20192018L011Rev4

DEM REFERENCE 2024D131832: RESPONSE TO FURTHER INFORMATION REQUEST

Tonkin has been engaged by Sandyridge Holdings Pty Ltd (Sandyridge) for the purpose of supporting the mining lease application at the company's Compton (formerly Buter's) Sandpit site. Our scope includes assisting with the response to the Department of Energy and Mining's (DEM) information request regarding the mining lease application over mineral claim (MC) 4537.

Attachment 15 – Updated Figure 8

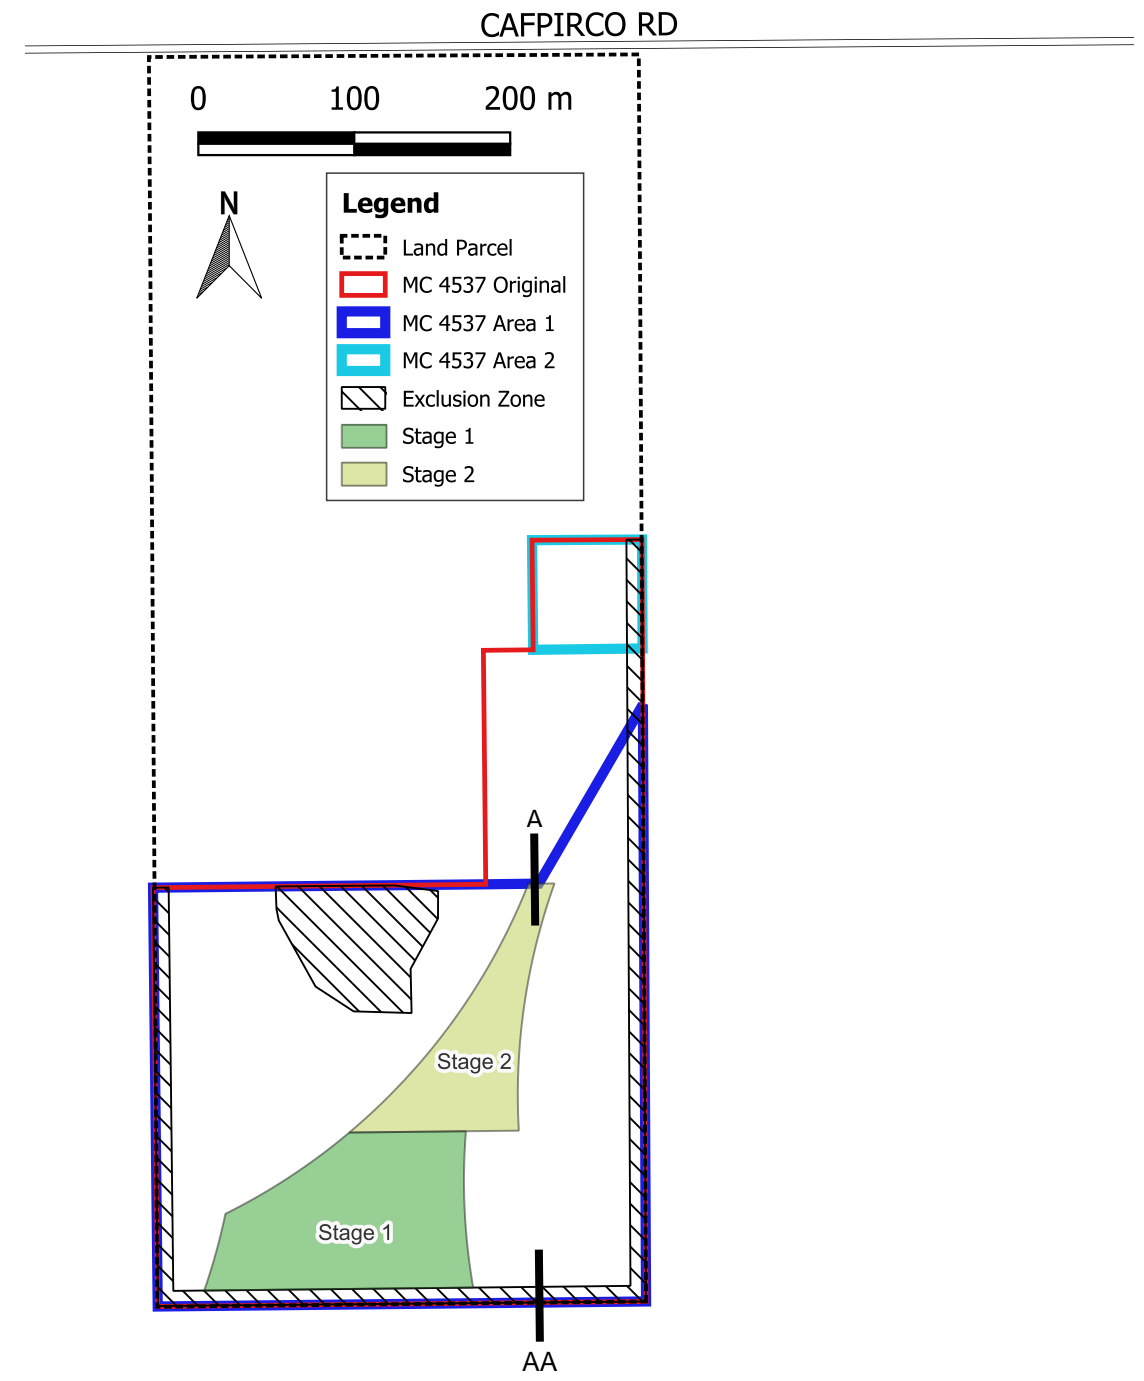
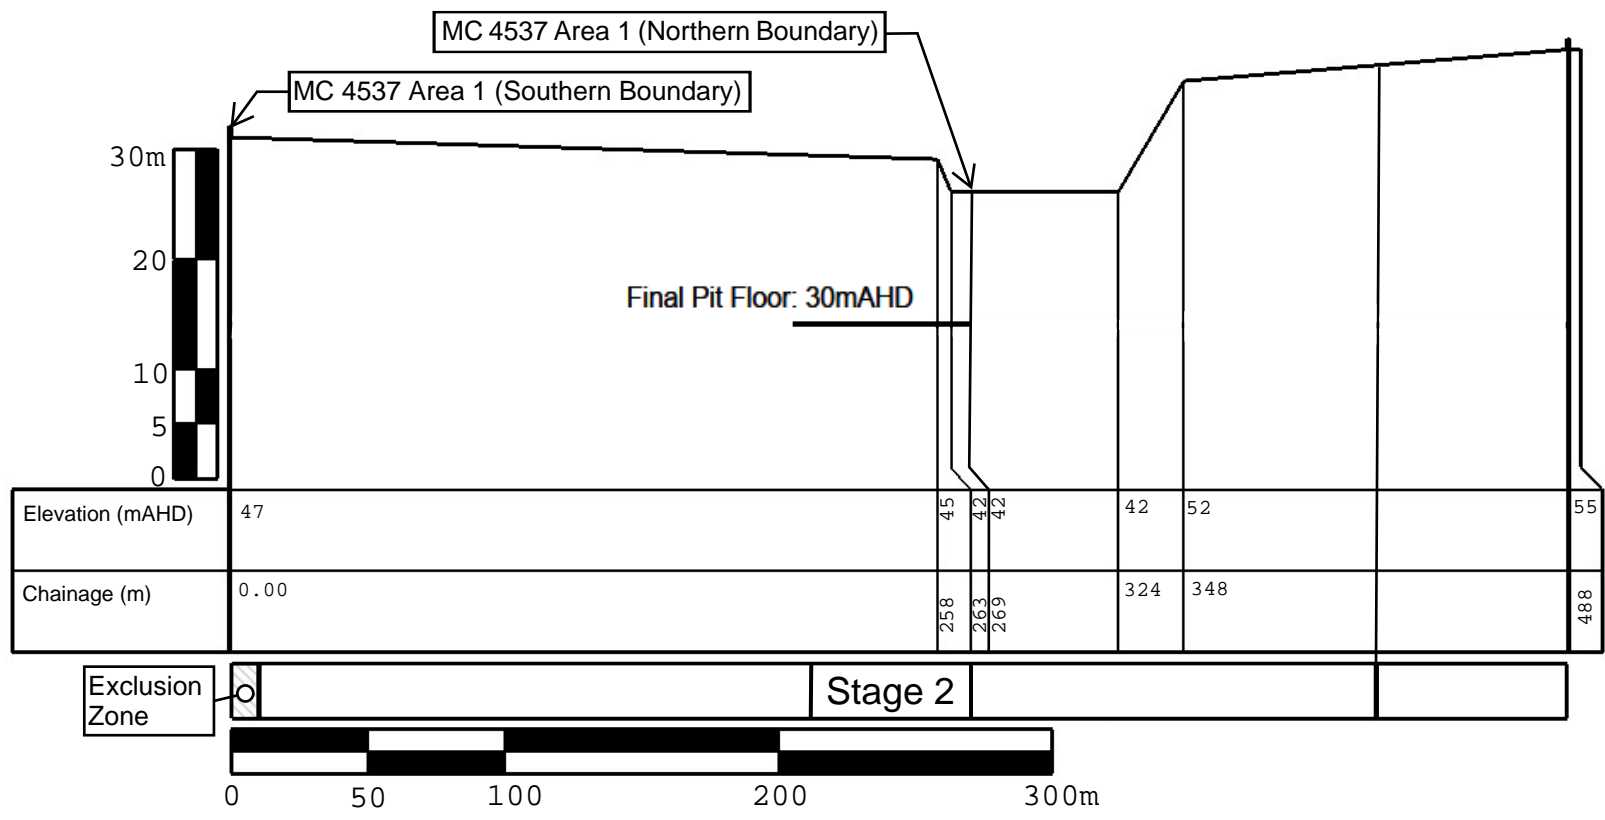
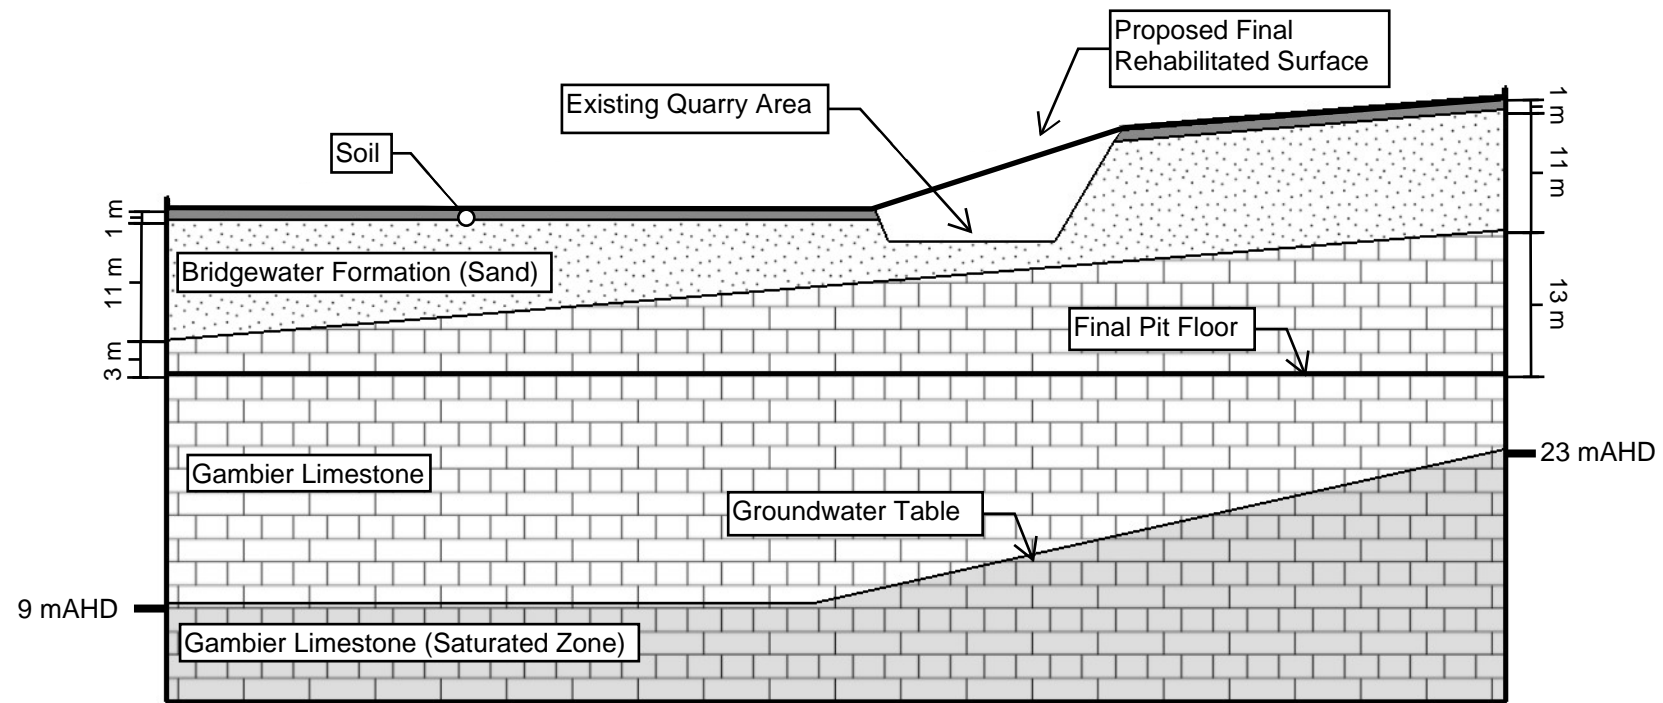
5.	Response prepared by Tonkin dated 31/1/2023 – 9. Quarry Site at Completion: Final Landform	<p>An updated cross section is provided which shows the proposed final rehabilitated landform aligned with the original surface contour. The pit floor is shown on the cross section at 30 mAHD (24 m below the natural surface contour).</p>	<p>Confirm that the volume of waste derived fill (inert waste) and overburden will be sufficient to fill to the original surface contour over the mine life.</p>	<p>An updated Table 4.2 Estimated Mineral Resource Supply, which is provided in Attachment 10, estimates that approximately 447,370m³ of materials will be quarried of which approximately 40,000m³ is overburden over the mine life. Thus it is estimated that 407,370 m³ of waste derived fill will be required to be imported to the site for rehabilitation. Sandyridge confirms that this volume of material will be able to be imported across the mine life.</p>

Attachment 16 – Updated Figure 9

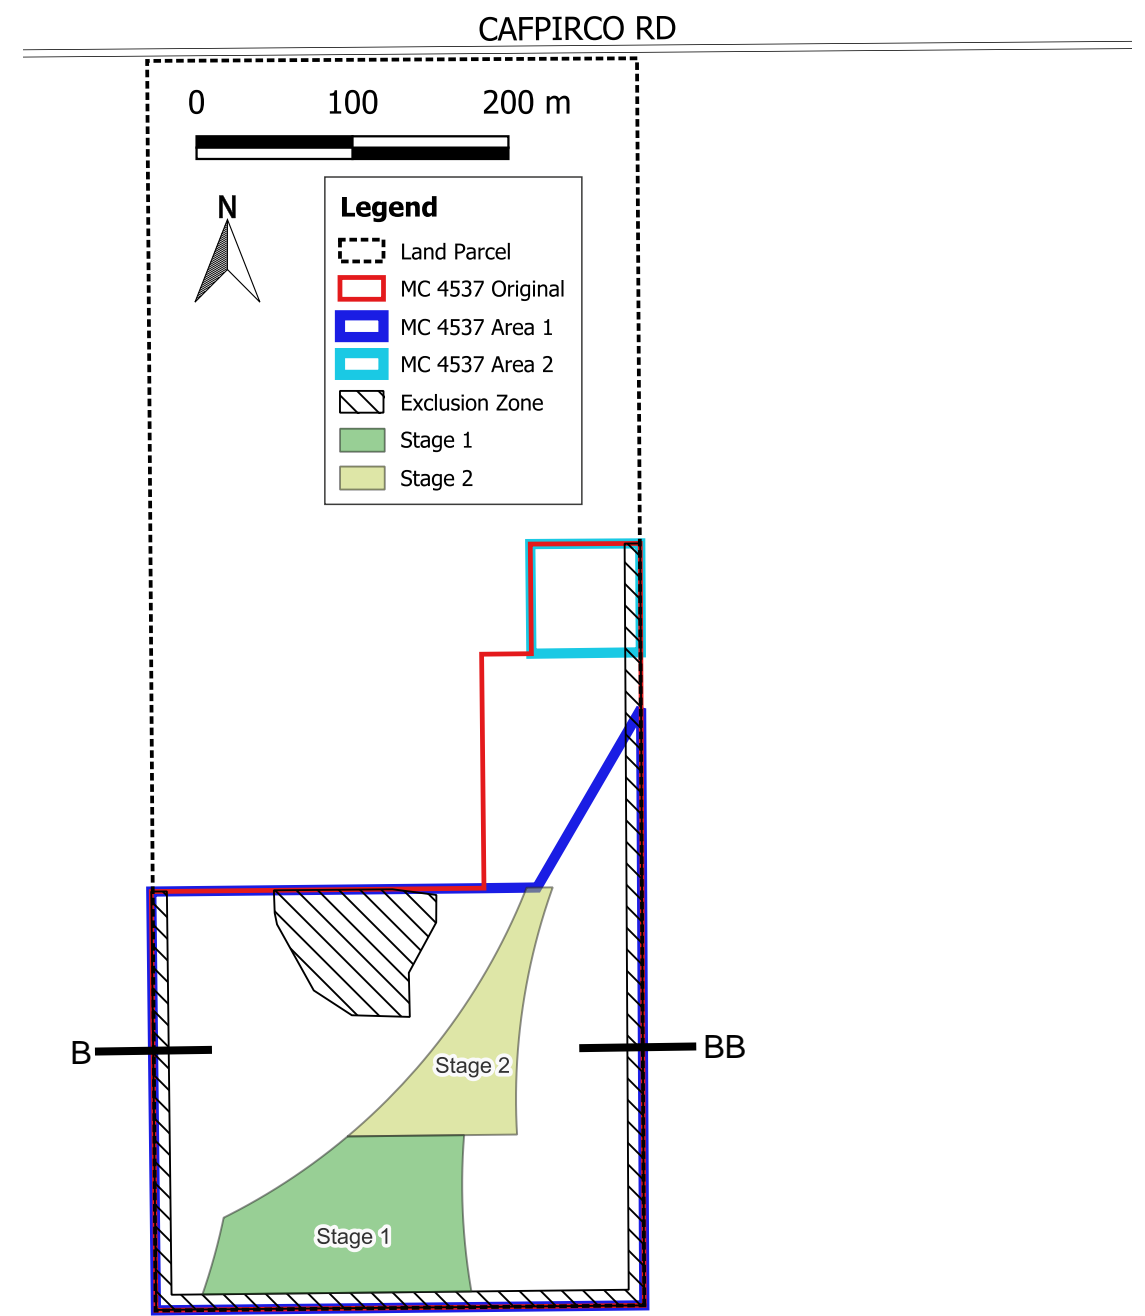
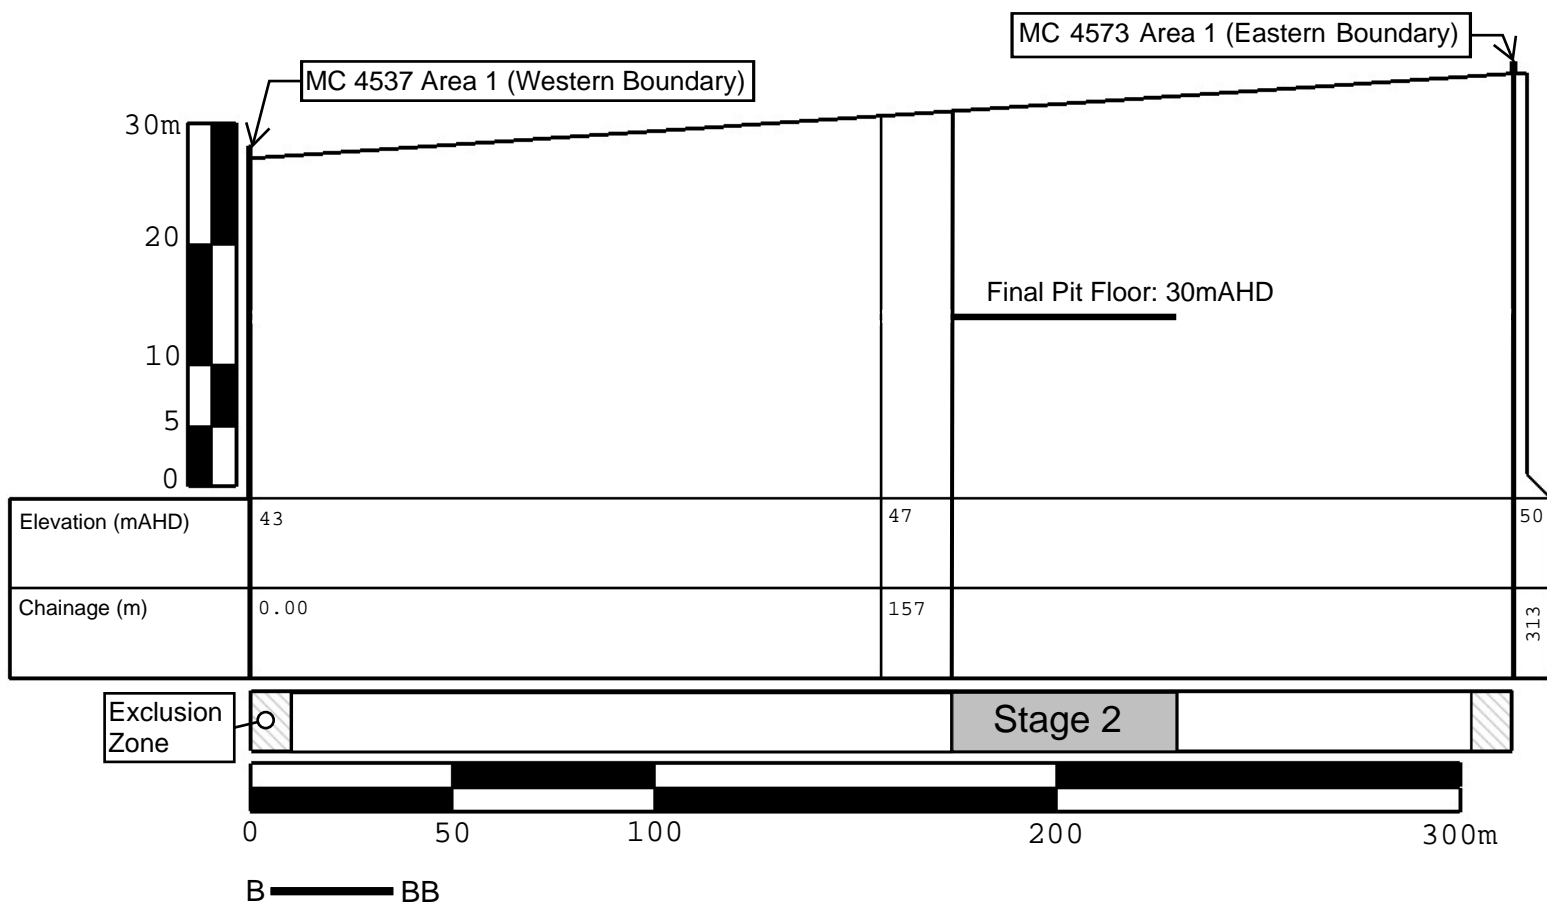
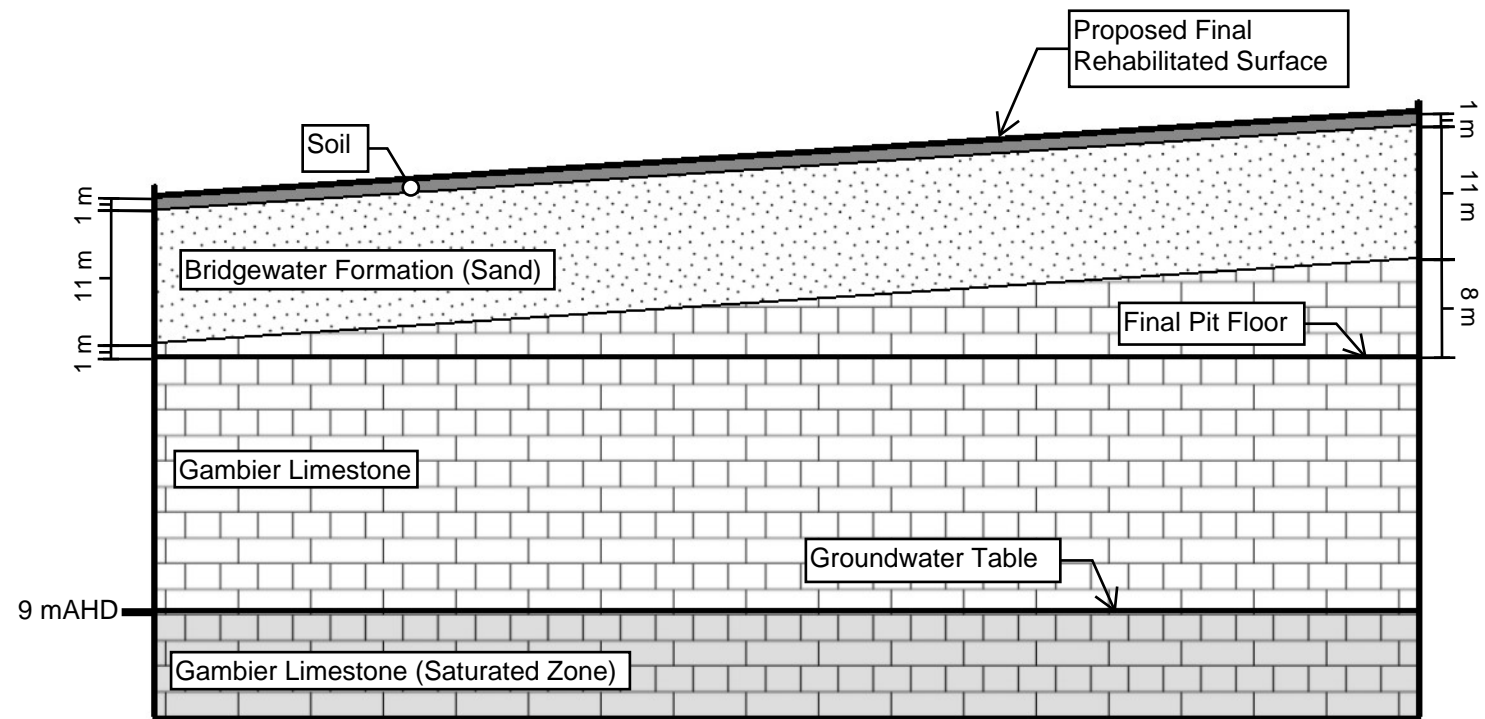
#	Topic	Description of Matter Raised by SA Government	Further Information or Clarification Required	Sandyridge's Response
9	4.8 Quarry Site at Completion: Final Landform	<p>The rehabilitation of the future quarry areas and final landform is described in the text as being returned "to pre-quarrying site contours".</p> <p>However, the north-south cross section provided on page 25 shows that in Stages 6, 7 & 1, the 'proposed final rehabilitated surface' extends higher than the existing 'soil' level. This is does not result in the contours returning to pre-quarrying levels.</p>	<p>Please clarify the proposed final landform for the whole site and provide updated cross sections depicting the final landform.</p>	<p>See the revised north-south cross section (Figure 8 provided in Attachment 15) with an amended final landform. Additionally, an updated Figure 9 is provided in Attachment 16 for the updated east-west cross section.</p>

Figure 10
 EPSG:28354

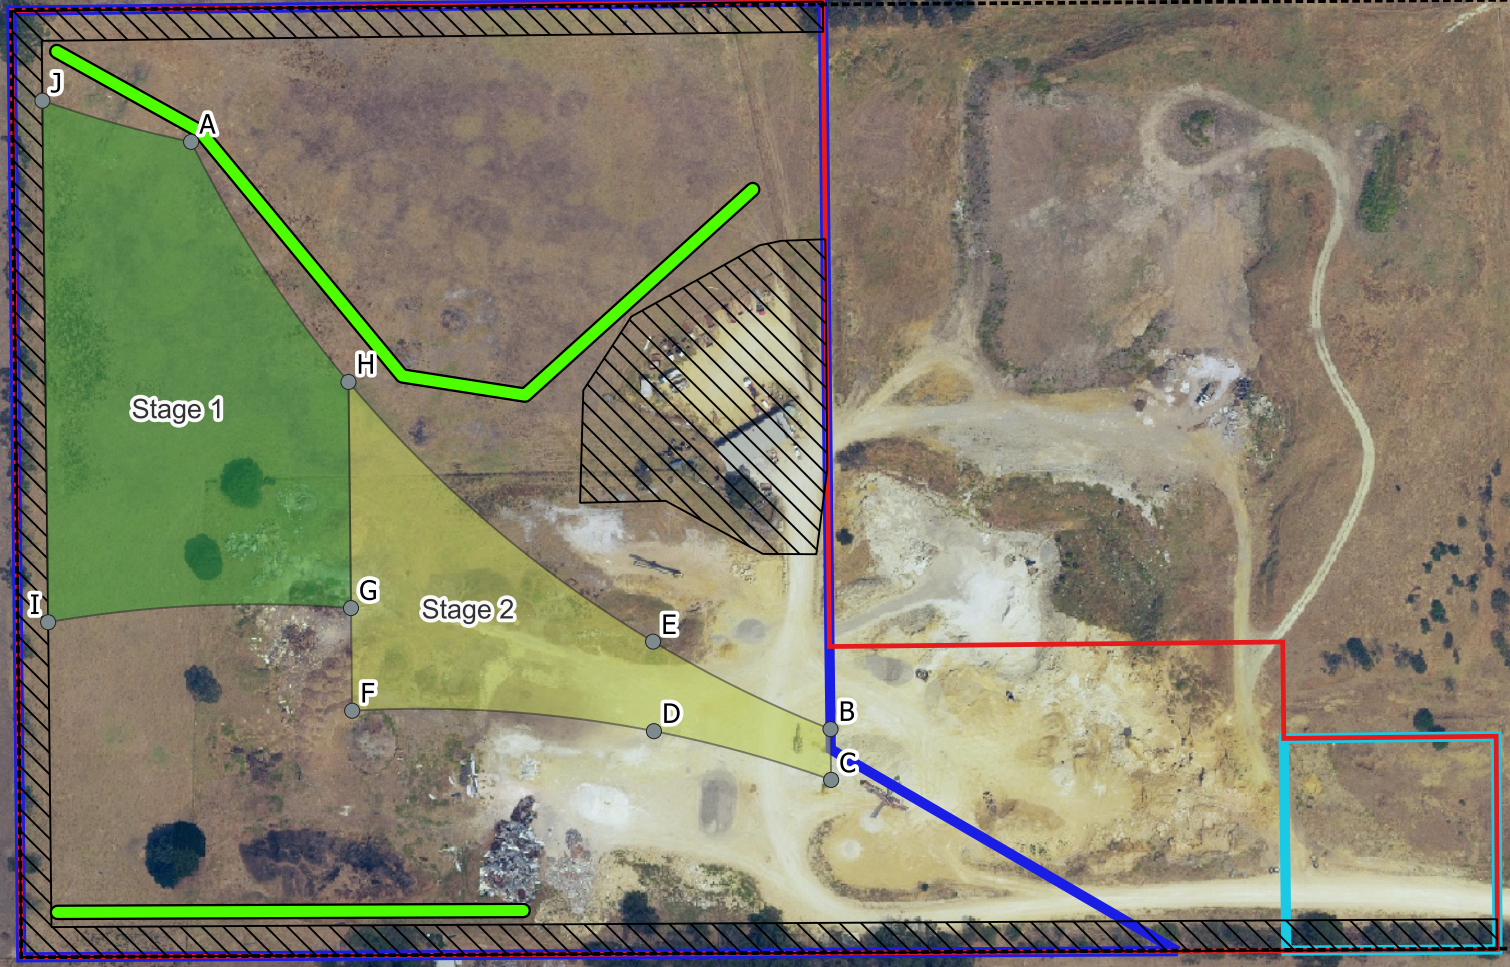
3.	Figure 10 Staging Plan	<p>The '<i>approximate additional bunding/screen planting location</i>' is considered mining operations.</p> <p>This bund/screen planting is located within exempt land and will require the beneficiary of the exempt land to waive their rights, in accordance with section 9AA of the <i>Mining Act 1971</i>.</p>	<p>Waivers of exemption are required.</p>	<p>Discussions with landowners regarding waivers of exemption for this activity are ongoing and reaching a well advanced stage. The waivers won't be provided by the time of submission of this letter. However, the waivers of exemption will be in place prior to any works related to this activity.</p>

#	Comment on Response Document	Further Information Required	Sandyridge's Response
1.	<p>Attachment 15 - Updated Figure 10 (Attachment 1) identifies a change/reduction in the proposed stages to be quarried to avoid exempt land where waivers have not been negotiated. Further information is required to describe how the amended stages will be quarried in an effective and efficient manner within the constrained area. There remains a possibility that waivers could be obtained through agreement or court processes. Further information is required to describe proposed mining should this occur.</p>	<p>A. Provide a description of the sequence of quarrying and progressive rehabilitation, as outlined in 2.2.2 of Terms of Reference (TOR) 003 in the areas constrained by exempt land.</p> <p>B. Provide proposed control measures to ensure no mining within exempt land.</p> <p>C. Provide a description of the sequence of quarrying and progressive rehabilitation if waivers can be obtained.</p>	<p>A. Quarrying activities will be conducted in sequential stages progressing from the south of the property to the north where it will eventually be exhausted when it reaches the boundary of the historical EML5990.</p> <p>The sequence of quarrying activities commences with clearing of vegetation and grasses before top soil is cleared and stored in dedicated top soil stockpiles of less than 3.0m in height. Small stripes of topsoil (~20m wide) are removed along the advancing pit face and placed in the stockpiles and bunds. These stockpiles are planted with grasses to maintain biome health in the soil and reduce dust and erosion from the stockpiles.</p> <p>Overburden will be then cleared using an excavator, transported by a front-end loader and stored separately in dedicated stockpiles. Topsoil and overburden will be used in the construction of the external earthen bunds to aide with noise and visual amenity impact for the neighbours.</p> <p>In most of the identified quarrying zone, sands are located beneath the overburden and on top of the underlying limestone layers. Extracted sand and limestone material is sorted into designated stockpiles located on the pit floor and in the stockpile yard.</p> <p>Excavated areas will be backfilled with inert waste and capped with native or imported topsoil. The backfilling rate is anticipated to be half the excavation rate.</p> <p>No more than two pits will be open at a time. Filled and capped pits will be sown to pasture (native/mixed pasture). Temporary infrastructure (i.e. sheds) will be dismantled if required before the land is sold or otherwise relinquished.</p>

2.	<p>EML 5990 was granted on 15 August 1997. Exempt land related to this EML, was determined at the time of tenement grant. At the time of grant, the subdivision of the land west of EML 5990 and PM 310 had not occurred, therefore there was no exempt land.</p>	<p>A. Provide clarification on the desired approach.</p> <p>B. If Sandyridge applies over a portion of MC 4537, provide an updated map with co-ordinates</p>	<p>A. Sandyridge will excise the overlapping areas between MC 4537 and EML 5990 to ensure there is no confusion or over-pegging of the tenements.</p> <p>B. An updated Figure 10 Staging Plan is provided in Attachment 17.</p>
